SPR 96-145

SITE PLAN REVIEW

Project Name: Office Building

TITLE HEADING: Site Plan Review - Cucchetti,
Baldwin Office Building

LANDSCAPE PLAN
 LANDSCAPE DESIGN BY TODD PICKFORD, GRAND JUNCTION NURSERY, INC.

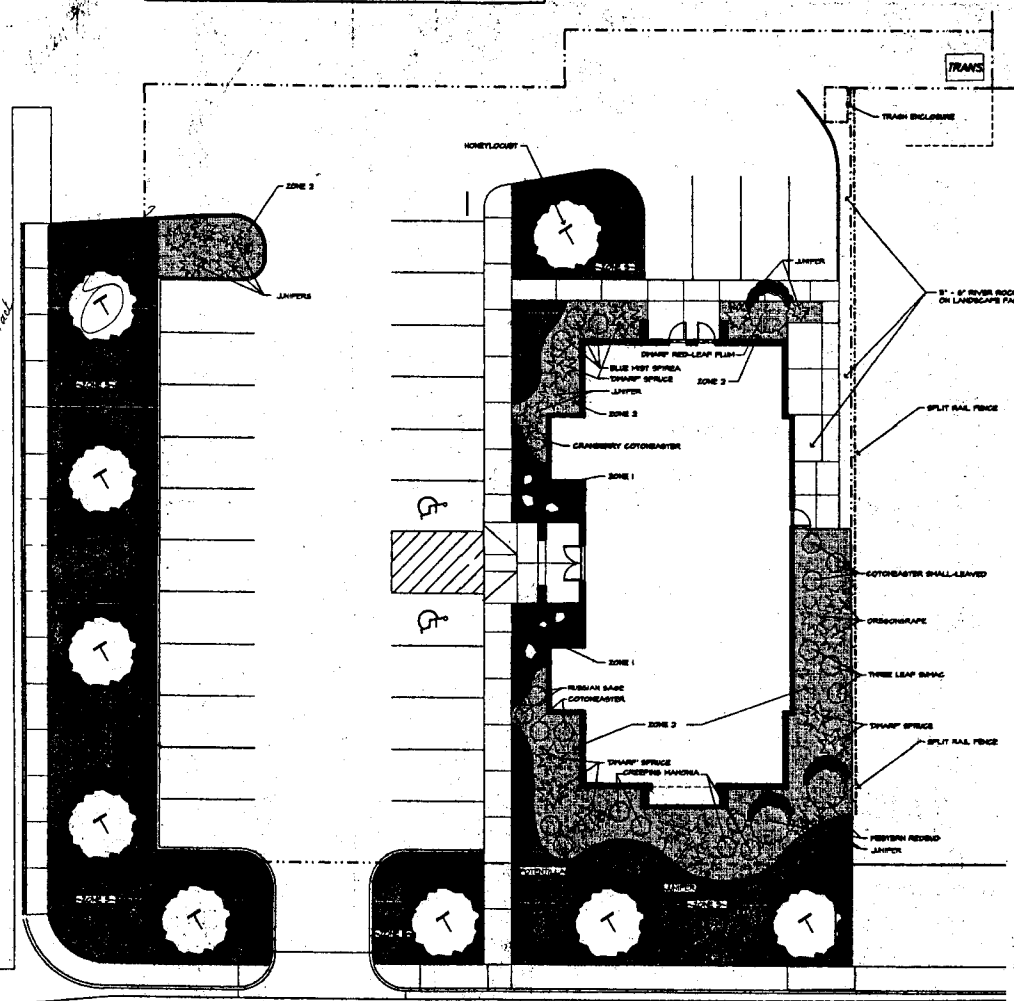
1. Minimum on-site landscape requirement of 1,300 sf is met with plan as proposed. Calculation of landscape area on Site Plan is not added correctly (totals 1,330, not 1,130).
2. Verify use of species and spacing of trees in the public right-of-way with City Parks & Recreation Department (Mike Vendegna 244-1549).
3. Provide a summary table/legend of species, planting size and number of landscaping proposed. Minimum size is 1-1/2" caliper trees and 5 gallon shrubs.
4. Add a note per Code: "An underground, pressurized irrigation system is required for all landscaped areas". This includes landscaping areas in the public rights-of-way.
5. An Improvements Agreement & Guarantee will be required for landscaping not completed prior to issuance of a Certificate of Occupancy for the proposed building.

Project #
9506
 Phase
 CD
 Issue Date
 08/02/98
 Revision
 07/08/98
 Sheet No.
C1

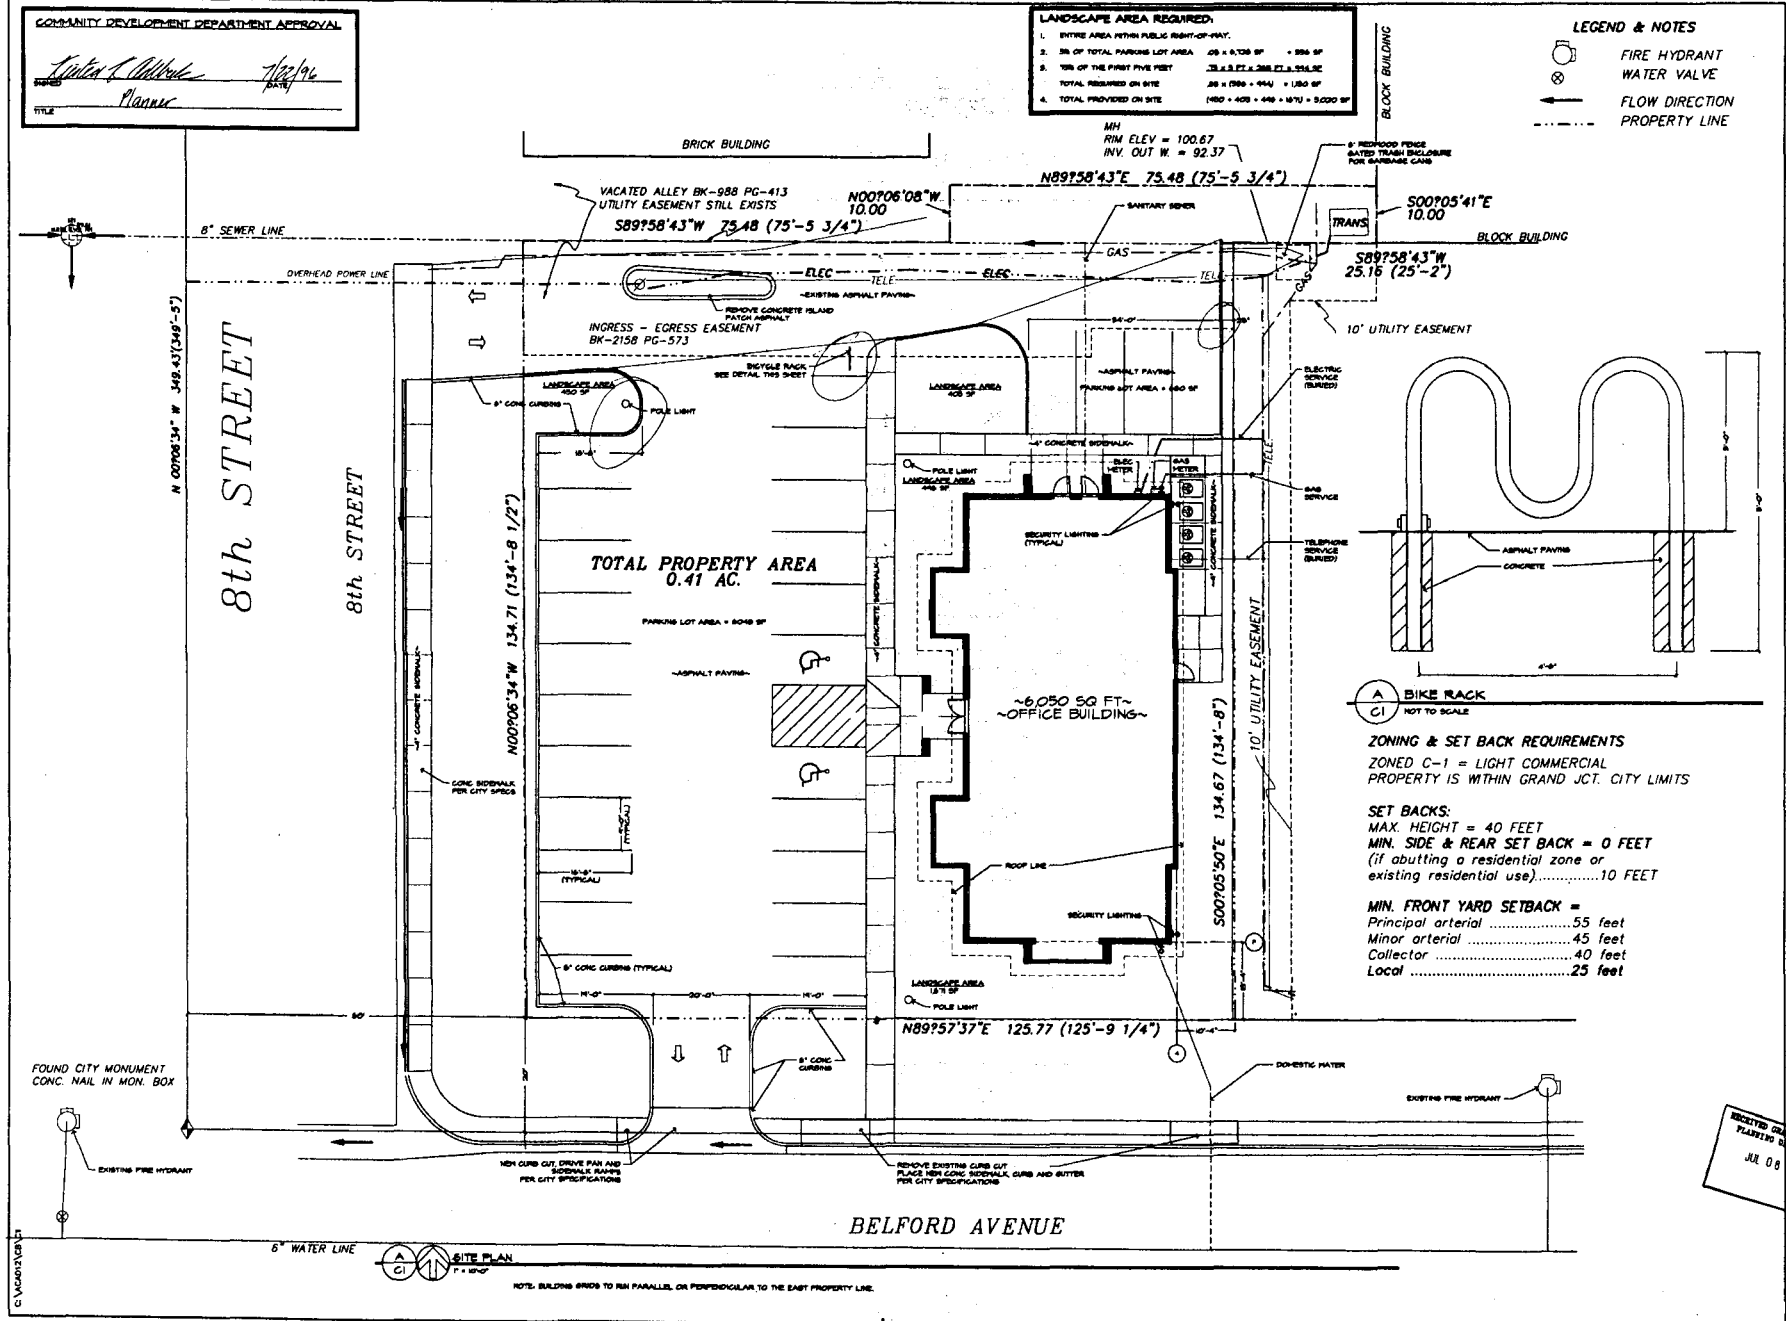
1. 16.5-foot parking stalls with overhang in turf area on west side of site is acceptable. Substandard stalls (less than 18.5-foot) that require vehicles to overhang on sidewalk are not acceptable (those on west and north sides of building). Either detach sidewalk from curb or provide a wider sidewalk.

1. Parking dimensions do not meet code requirements for 18.5' stall lengths and a 25' wide aisle.
2. The minimum width of a commercial curb cut is 20'.
3. A permit is required from City Engineering for any concrete work in the right of way including curb cuts and sidewalk.
4. TCP credit may be allowed for new sidewalk construction. TCP is calculated at \$2400.00.
5. A drainage fee of \$850.94 is payable when planning clearance is issued.

1. The parking stall depths were reduced to 16'-6" to allow the curbs to function as wheel stops. This was discussed with Kris on April 15. The aisle is 25' using 16'-6" deep stalls.
2. The curb cut at the south entry will be increased to 20'.
3. Contractor will apply for permit to work in ROW.
4. Please advise on possible credit on TCP for new sidewalk construction.
5. Drainage fee will be paid upon planning clearance.
